Sum, Sum Pro & Krypton Pro - Seatpost Saddle Top Clamp Replacement Program

Quality and reliability of our products always being our top priority, we are now implementing a **Seatpost Saddle Top Clamp Replacement Program** for all Sum, Sum Pro & Krypton Pro bikes manufactured since 2020 up to 2024. Although there have been no incidents reported to us to this date, some inspection reports show the appearance of cracks on certain seatpost saddle top clamps, which may present a potential issue. Therefore, as a proactive and preventive measure, Argon 18 is setting up this replacement program for any affected Sum, Sum Pro & Krypton Pro manufactured since 2020 up to 2024.

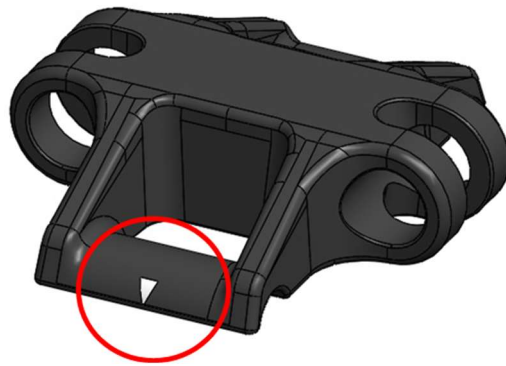
To carry out this inspection and confirm if your seatpost saddle top clamp requires to be replaced, please look underneath your saddle and refer to the images below:

Seatpost top clamp needing replacement
(without white arrow)

New seatpost saddle top clamp
(with white arrow)

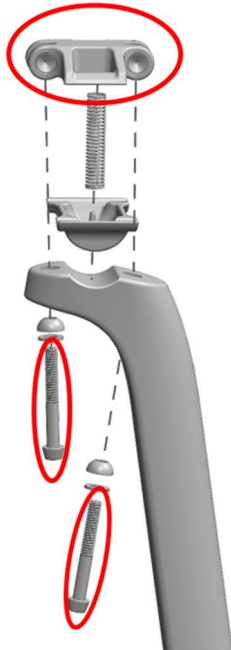
Assembled seatpost top clamp needing replacement
(without white arrow)

New seatpost saddle top clamp assembled
(with white arrow)

1. Please note that there is **no spring needed** with the new seatpost saddle top clamp configuration. Therefore, it must be removed and discarded when replacing the seatpost saddle top clamp.
